In re: K269GG, Austin, TX
BMPFT-20161031AEQ
Facility ID No. 148525

This refers to the above-captioned minor change application.

Overlap Attachment:

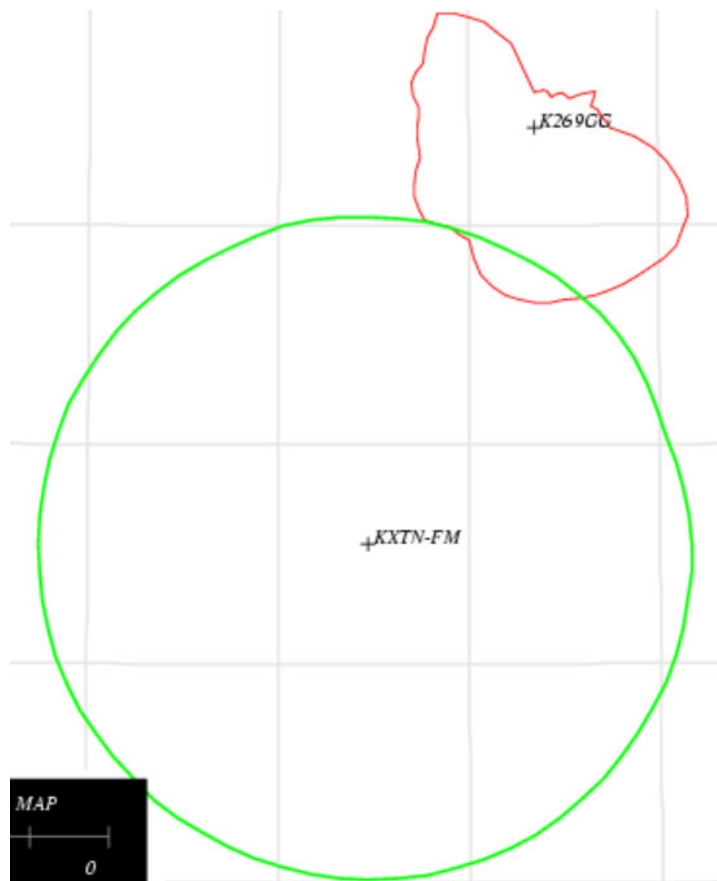
An engineering study reveals the application is in violation of the interference protection requirements of 47 C.F.R. Section 74.1204. Specifically, the proposed 40 dBu interfering contour overlaps the 60 dBu protected contour of the authorized facilities of co-channel station KXTN-FM, San Antonio, Texas (BLH-20060612AAY). The application does not recognize this defect. Accordingly, we dismiss the application as unacceptable for filing.

Red contour – Proposed K269CG, 40 dBu interfering contour
Green contour – KXTN-FM, 60 dBu protected contour

In light of the above, application BMPFT-20161031AEQ is unacceptable for filing pursuant to 47 C.F.R. § 73.3566(a) and IS HEREBY DISMISSED. This action is taken pursuant to 47 C.F.R. § 0.283.
